Product Change Notice (PCN)

件名: RH850/F1KM-S4 シリーズの生産拠点の追加および材料変更

発行日: 3/6/2025

[現行] WP : TSMC、組立/FT : 蘇州

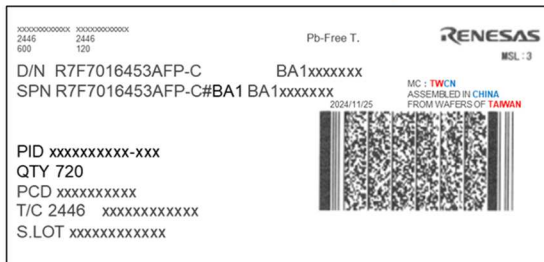
那珂品は赤文字部分が異なります。(TSMC 品:T, 那珂品:N)

ATJ 熊本品はトレースコードの桁数(青文字部分)が異なります。(蘇州品:7桁, ATJ 熊本品:9桁)
また外形が異なります。

[追加] WP : 那珂、組立/FT : 蘇州

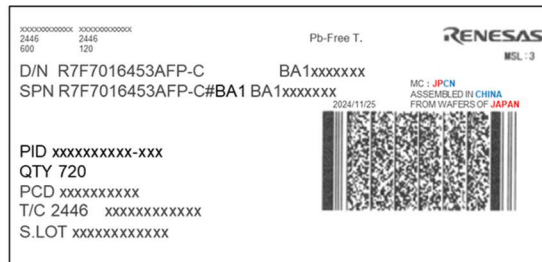
那珂品は赤文字部分が異なります。

[追加] WP : 那珂、組立/FT : ATJ熊本

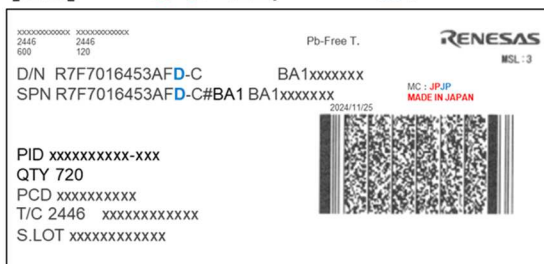
また ATJ 熊本品、Tera Probe 品は青文字部分が異なります。
